HYUNDAI Technical Service Bulletin

Subject AIRBAG CONTROL UNIT VINYL COVER INSTALLATION AND SIDE AIRBAG CONNECTOR CLIP REPLACEMENT (CAMPAIGN 088)	Group CAMPAIGN		
	Number 08-01-025		
	Date NOVEMBER, 2008		
	Model 2001 - 2002 ELANTRA		
CIRCULATE TO:	☐ GENERAL MANAGER	☒ PARTS MANAGER	☒ TECHNICIAN
☒ SERVICE ADVISOR	☒ SERVICE MANAGER	☒ WARRANTY MGR	☐ SALES MANAGER

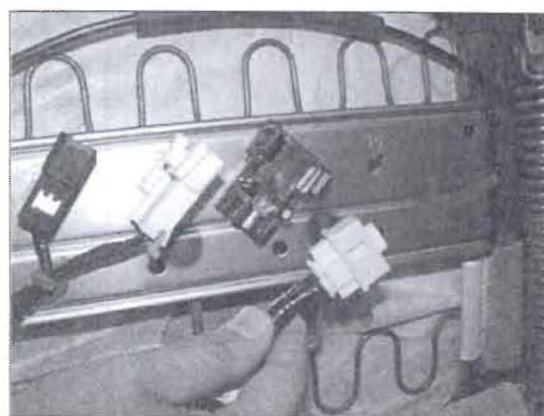
5. Tilt the driver's seat assembly rearward and disconnect the Buckle Switch, the Buckle Sensor and the side airbag (SAB) wiring connectors on the seat under frame.

6. Remove the SAB module wiring connector from the SAB wiring connector clip.

7. Remove the SAB wiring connector clip from the seat under frame and install a new wiring connector clip supplied in the kit.

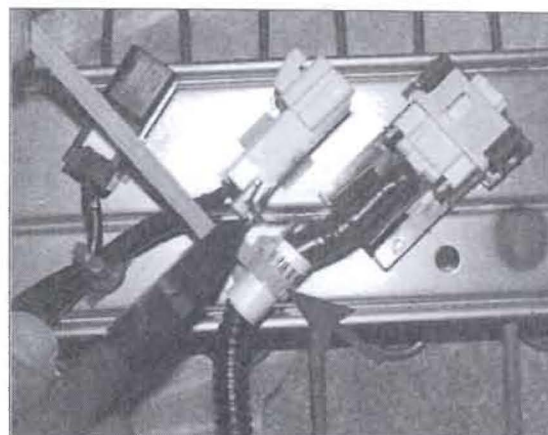
8. Reinstall the SAB module wiring connector to the new wiring connector clip in the direction of the arrow.

9. Tie the SAB wire loosely with the new wire tie supplied in the kit and insert the wire tie anchor point into the seat frame hole until it snaps into place (see photo). Adjust the SAB wire and tighten the wire tie. Cut off the excess wire tie using a wire clipper.

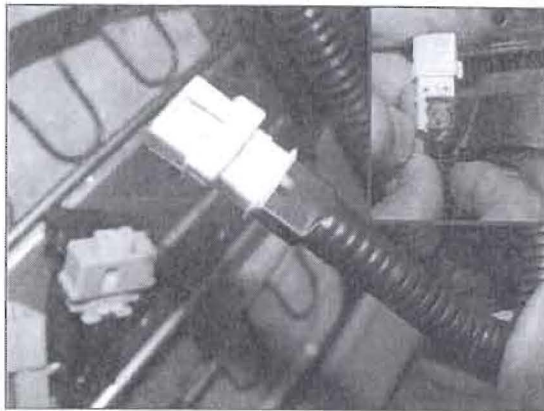
10. Remove the wrapped electrical tape over the airbag floor wiring connector and the corrugated tube.

11. Using new electrical tape, tape the airbag floor wire, covering the connector and the end of the corrugated tube as shown in the photo.

NOTE: Be sure to push the corrugated tube end against the connector when taping.

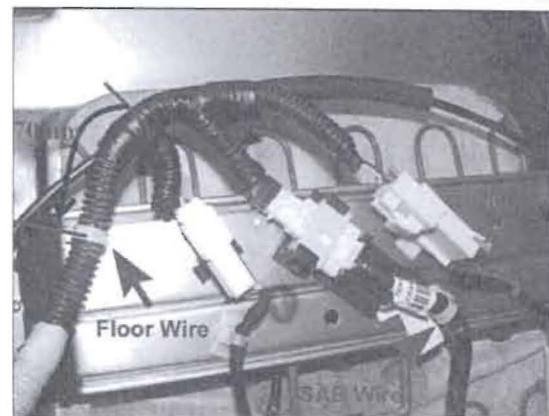
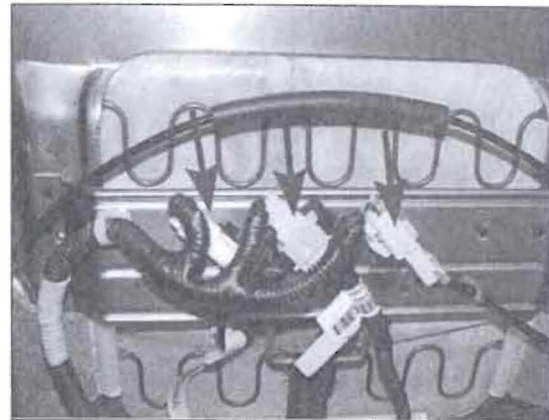
12. Reconnect the 3 wiring connectors and loosely tie the airbag floor wire with a wire tie. Insert the wire tie anchor point into the seat frame hole until it snaps into place. Adjust the airbag wiring and tighten the wire tie. Cut off the excess cable using a wire clipper.

NOTE: Be careful not to bend the wire harness at the connector.

NOTE: Be sure to tie the air bag floor wire approximately 1 ¾ inches (40mm) from the point it splits to the 3 connectors.
